United States Patent and Trademark Office

APPLICATION NO.	FILING DATE	FIRST NAMED INVENTOR	ATTORNEY DOCKET NO.	CONFIRMATION NO.
10/014,227	12/11/2001	Benoit R. Veillette	US010594	3093
24737	7590 01/18/2006		EXAMINER	
PHILIPS INTELLECTUAL PROPERTY & STANDARDS			TAYLOR, BARRY W	
	P.O. BOX 3001 BRIARCLIFF MANOR, NY 10510		ART UNIT	PAPER NUMBER
J			2643	
			DATE MAILED: 01/18/2006

Application No.	Applicant(s)
Office Action Summary		10/014,227	VEILLETTE, BENOIT R.
		Examiner	Art Unit
		Barry W. Taylor	2643
Period fo	The MAILING DATE of this communication apor Reply	ppears on the cover sheet with the	correspondence address
A SH WHIC - Exte after - If NC - Failu Any	ORTENED STATUTORY PERIOD FOR REPLEVER IS LONGER, FROM THE MAILING Insions of time may be available under the provisions of 37 CFR 1 SIX (6) MONTHS from the mailing date of this communication. Depriod for reply is specified above, the maximum statutory perior re to reply within the set or extended period for reply will, by statutely reply received by the Office later than three months after the mailed patent term adjustment. See 37 CFR 1.704(b).	DATE OF THIS COMMUNICATION 1.136(a). In no event, however, may a reply be tind d

FIG. 1

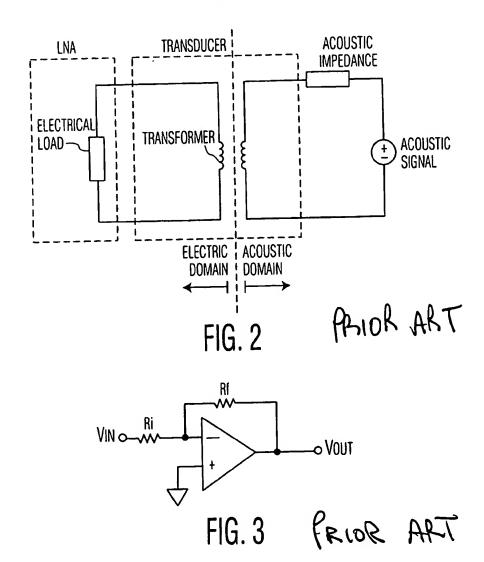
Regarding claim 1. Applicants openly admit that prior art teaches a receiver circuit (see RECEIVER in figure 1), comprising:

a switch for blocking high voltages and for converting voltage signals to current signals (see T/R switch in figure 1), said switch comprising first and second signal terminals (see conventional T/R switch depicted in figure 4B wherein first terminal is labeled as 405 and second terminal labeled as 410) and a control terminal (see control terminal labeled as 400 figure 4B) said switching exhibiting an ON resistance when closed, said ON resistance controlled by an electric value at said control terminal;

Regarding claim 8. Applicants openly admit that prior art teaches a receiver circuit (see RECEIVER in figure 1), comprising:

a T/R switch for blocking high voltages and for converting voltage signals to current signals (see T/R switch in figure 1), said T/R switch comprising first and second signal terminals (see conventional T/R switch depicted in figure 4B wherein first terminal is labeled as 405 and second terminal labeled as 410;
